**PARK CITY MUNICIPAL CORPORATION
PLANNING DEPARTMENT ADMINISTRATIVE PUBLIC HEARING MINUTES
PLANNING DEPARTMENT CONFERENCE ROOM
MARSAC MUNICIPAL BUILDING
MARCH 19, 2026**

- A. 954 Woodside Avenue – Administrative Conditional Use Permit –** The Applicant Proposes a Retaining Wall Greater than Four Feet in the Required Front Yard Setback, Historic Residential - 1 Zoning District. PL-26-06828.

- B. 384 Woodside Avenue – Historic District Design Review –** The Applicant Proposes to Construct a New Single-Family Dwelling at a Non-Historic Site in the Historic Residential - 1 Zoning District. PL-25-06388.

Figure 1: Excerpt from Applicant's plans with staff's measurements of the garage

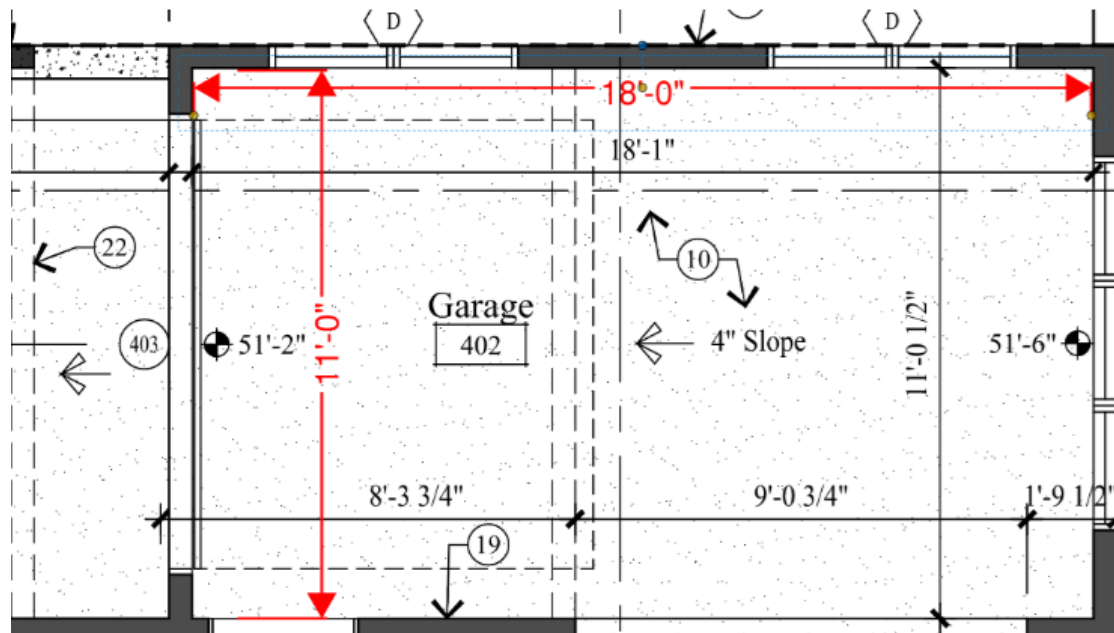
- d. The Applicant's plans show the garage has a depth of 18 feet, which meets the HR-1 requirement according to the Building Height Exception for Garages on a Downhill Lot, which states the depth of the garage shall not exceed the minimum depth for internal Parking Space(s), pursuant to LMC § 15-3-3(F), *Parking Space Dimensions*, which is 18 feet in depth.

18. The depth of the garage shall be 18 feet unless the Planning Commission approves a modification application to amend Condition of Approval #8(A) in the Planning Commission's November 12, 2025, Final Action Letter. The plans shall be updated prior to Building Permit submittal accordingly.
